UNITED STATES PATENT AND TRADEMARK OFFICE

APPLICATION NO.	FILING DATE	FIRST NAMED INVENTOR	ATTORNEY DOCKET NO.	CONFIRMATION NO.
10/613,605	07/03/2003	David DeRogatis	RAILWA 3.0-001	7300

Office Action Summary	Application No.		Applicant(s)	
	10/613,605		DEROGATIS ET AL.	
	Examiner		Art Unit	
	Ernesto Garcia		3679

DETAILED ACTION

Abukawa, 5,392,582

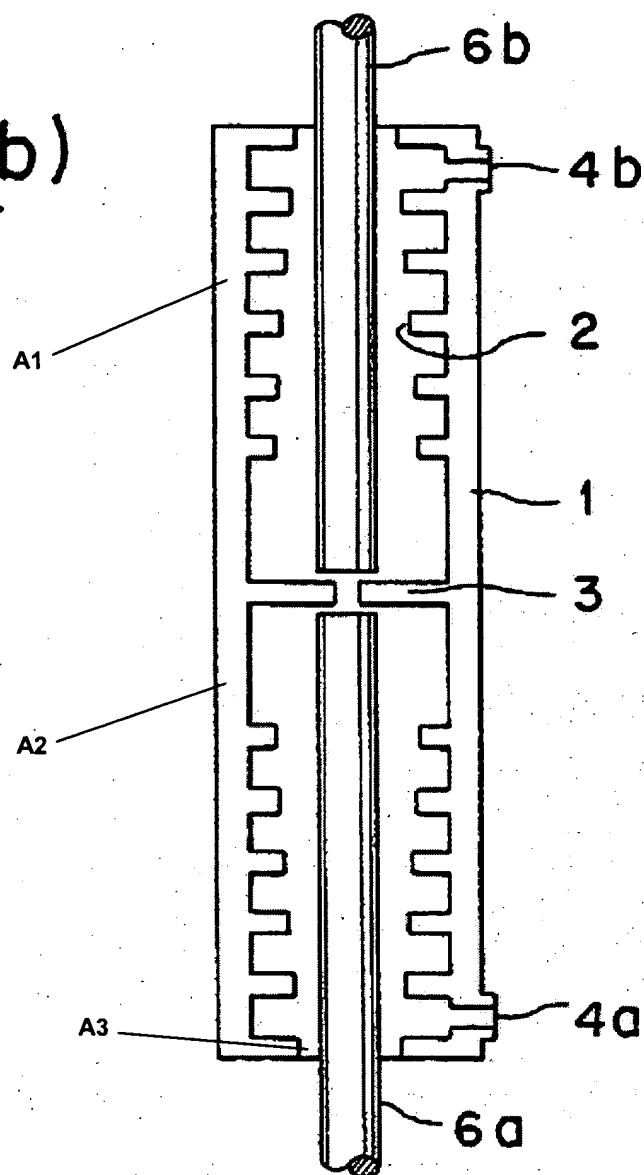
Regarding claim 1, Abukawa discloses, in Figure 6a, a plug fastener 1 comprising a first engaging portion **A1** (see marked-up attachment) and a second engaging portion **A2**. The first engaging portion **A1** has first ridges **2**. The second engaging portion **A2** has second ridges **2**. The first ridges **2** and the second ridges **2** extend parallel with respect to each other. An aperture **A3** extends through the plug fastener 1. The first ridges **2** and the second ridges **2** are concentric with respect to the aperture **A3**.

Regarding claim 7, pairs of corresponding ridges **2** from the first portion and the second portion provide symmetrical decreasing widths of the plug fastener away from an equator of the plug fastener perpendicular to the aperture **A3** (see Figure 6a).

Regarding claim 49, at least one of the first ridges **2** comprises an end slanted in a direction opposite than a direction an end of at least one of the second ridges **2** is slanted, and at least one of the second ridges **2** comprises an end slanted in a direction opposite than the direction the end of the at least one of the first ridges is slanted (see Figure 4).

Regarding claim 54, the plug fastener further comprising a fastening device **6b** disposed within the aperture **A3**.

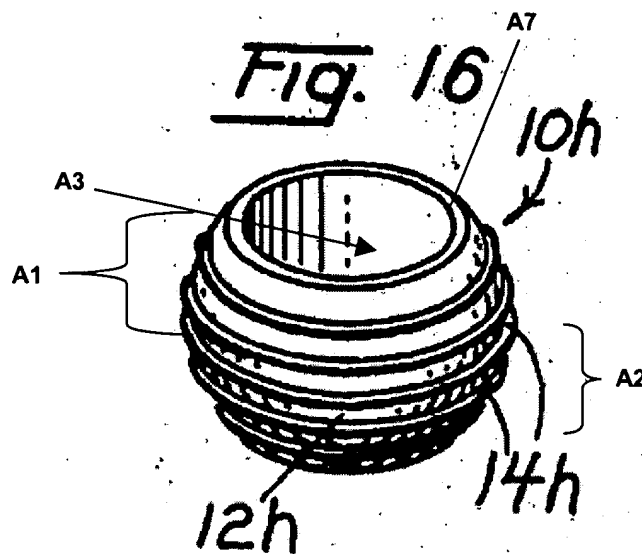
The drawings were received on November 28, 2006. These drawings are not acceptable because they introduce new matter. Note that the original drawings show a distinct plug fastener in Figures 13A, 14, and 15-17 (see attachment for elected species) than the drawings filed on November 28, 2006 and February 4, 2004, which have not been approved. Note that the differences between the corresponding plug fasteners are drastic. The original filed drawings show the plug fastener in Figures 15-17 with ridges projecting out of the exterior surface of the sphere, as also described at original paragraph 055, lines 11-15. The current Figures 15, 15A-15D, 16 and 21 now show the ridges being internal of the exterior surface of the sphere. Further, the ridges on the original plug fasteners in Figures 13A and 14 show the ridges being triangular and pointing toward each other from either portion. The new Figures 13A and 14A show the ridges being straight and not triangular.

Regarding claims 1 and 57, the recitations "ridges comprising parallel rectilinear sidewalls" in claim 1, lines 2 and 3, and claim 57, lines 4 and 7, are not supported by the written description requirement. Note that although the current drawings show this feature, the applicants cannot rely on these drawings to find support since the current

drawings show different types of ridges as compared to the original drawings filed with the application on July 7, 2003. See attachment. Note that originally, the ridges were triangular and the ridges of a first portion were directed towards the ridges of a second portion. Accordingly, these new limitations do not comply with the written description.

Regarding claim 61, the recitation "ends of the first and second ridges are tapered respectively from the first and second openings towards a maximum diameter of the plug fastener" in lines 1-3 is not supported by the original disclosure. Note that the original filed drawings contained triangular pointed ends and thus not tapered ends. See attachment. Accordingly, this limitation does not comply with the written description.
